Economic Commission for Europe**Inland Transport Committee****World Forum for Harmonization of Vehicle Regulations****183rd session**

1958 Agreement:**Consideration of draft amendments to existing****UN Regulations submitted by GRVA****Advance copy****Proposal for Supplement 2 to the 01 series of amendments to
UN Regulation No. 152 (AEBS for M₁ and N₁)****Submitted by the Working Party on Automated/Autonomous and
Connected Vehicles ***

Supplement 2 to the 01 series of amendments to UN Regulation No. 152 (AEBS for M₁ and N₁)

Figure 1:
Left turn or right turn at the intersection

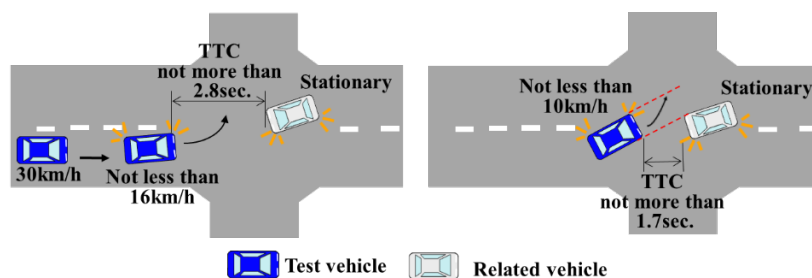
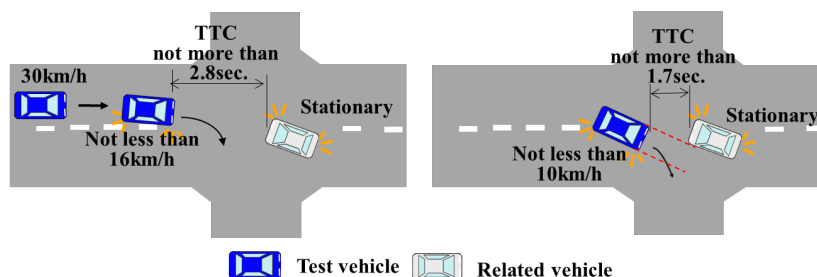
Insert new Scenarios 1 to 4, to read:

1.1. In this scenario, the subject vehicle passes by a left turn or right turn in front of an oncoming vehicle that is stopped to make a left turn or right turn at an intersection.

The subject vehicle drives at a speed of 30 km/h (with a tolerance of +0/-2 km/h) toward the intersection, and decelerates by braking to a speed of not less than 16 km/h at a point where the subject vehicle begins to steer left / right, and the Time To Collision (TTC) to the oncoming vehicle is not more than 2.8 seconds. When the subject vehicle turns left or right in the intersection, the speed is reduced to not less than 10 km/h, and then drives at a constant speed. The TTC to the oncoming vehicle is not more than 1.7 seconds at when the overlap ratio between the subject vehicle and the oncoming vehicle becomes 0 %.

Figure 2:
Right turn or left turn of a forward vehicle

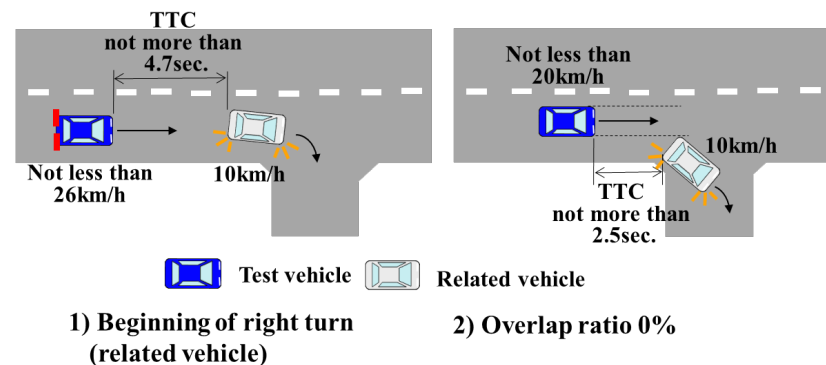
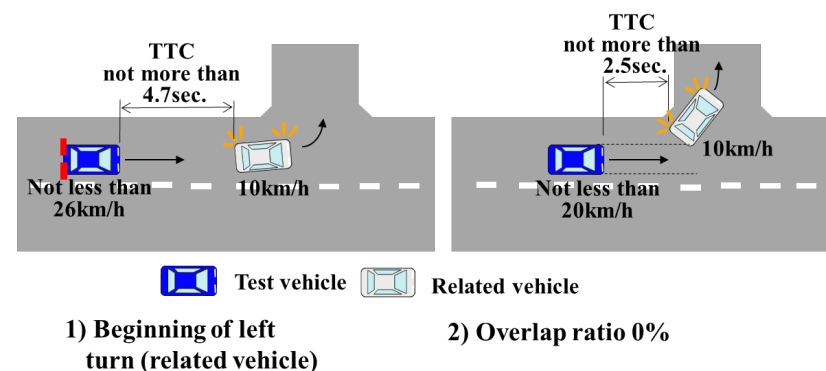
2.1. In this scenario, the subject vehicle follows a forward vehicle. After that, the forward vehicle turns right or left at a corner, and the subject vehicle goes straight.

Both the forward vehicle and the subject vehicle drive at a speed of 40 km/h (with a tolerance of +0/-2 km/h) on the straight road. The forward vehicle decelerates by braking to a speed of 10 km/h (with a tolerance of +0/-2 km/h) in order to turn right or left at the corner, and the subject vehicle also decelerates by braking to keep appropriate distance with the forward vehicle. At when the forward vehicle begins to turn right or left, the speed of the subject vehicle is not less than 26 km/h and the TTC to the frontal vehicle is not more than 4.7 seconds. After that, the subject vehicle decelerates to a speed of not less than 20 km/h, and then drives at a constant speed. The TTC to the forward vehicle is not more than 2.5 seconds at when the overlap ratio between the subject vehicle and the forward vehicle becomes 0 %.

Figure 3:
Curved road with guard pipes and a stationary object

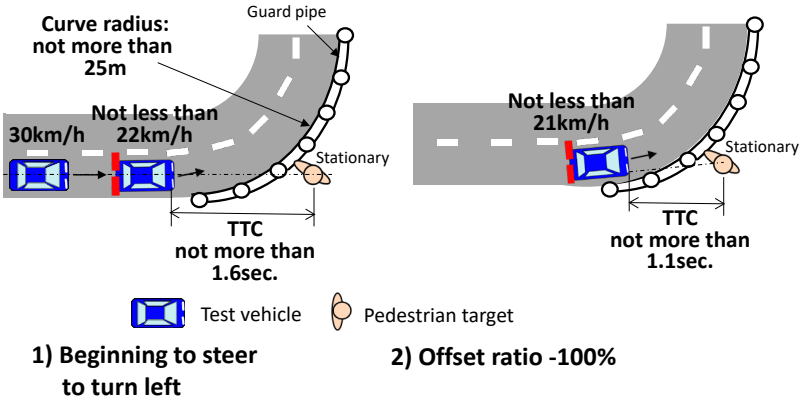
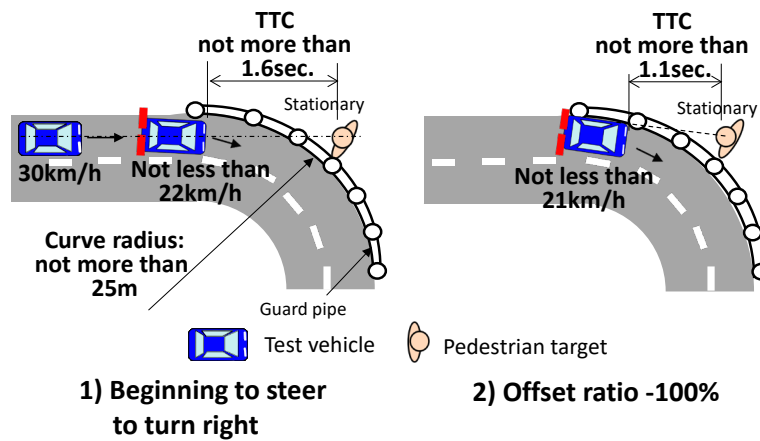
- 3.1. In this scenario, the subject vehicle drives a small radius curved road of which the guard pipes are constructed to the outer side, and a stationary vehicle (M₁ category), a stationary pedestrian target or a stationary bicycle target is positioned just outside of the guard pipes and where on the extension of the centre of the lane.

- 3.2. An example of the detail scenario:
 The subject vehicle drives at a speed of 30 (with a tolerance of +0/-2 km/h) km/h toward the curve of which the radius is not more than 25 m at the outer side of the road, and decelerates by braking to a speed of not less than 22 km/h at a point where the subject vehicle enters the curve. The TTC to the stationary object is not more than 1.6 seconds at when the subject vehicle begins to turn in the curve. In the curve, the subject vehicle drives outer lane than the centre of the road. After that, the subject vehicle continue to turn in the curve at a constant speed of not less than 21 km/h. The TTC to the stationary object is not more than 1.1 second at when the overlap ratio between the subject vehicle and the stationary vehicle becomes 0%, or at when the offset ratio between the subject vehicle and the centre of the stationary pedestrian target or the stationary bicycle target becomes -100%.

Figure 4:
Lane change due to road construction

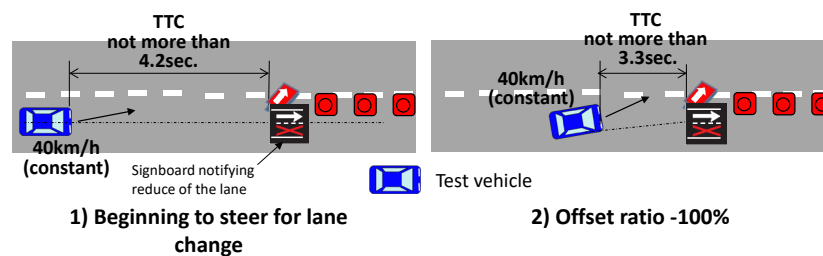
- 4.1. In this scenario, the subject vehicle changes the lane in front of the signboard which is positioned in the centre of the lane and notifies the driver that the lane is reduced.
- 4.2. An example of the detail scenario:
 The subject vehicle drives a straight road at a speed of 40 km/h (with a tolerance of +0/-2 km/h) and begins to steer in order to change the lane in front of the signboard which notifies reducing the lane. No other vehicles approach the subject vehicle. The TTC to the signboard is not more than 4.2 seconds at when the subject vehicle begins to steer. During changing the lane, the speed of the subject vehicle is constant, and the TTC to the signboard is not more than 3.3 seconds at when the offset ratio between the subject vehicle and the centre of the signboard becomes -100%.
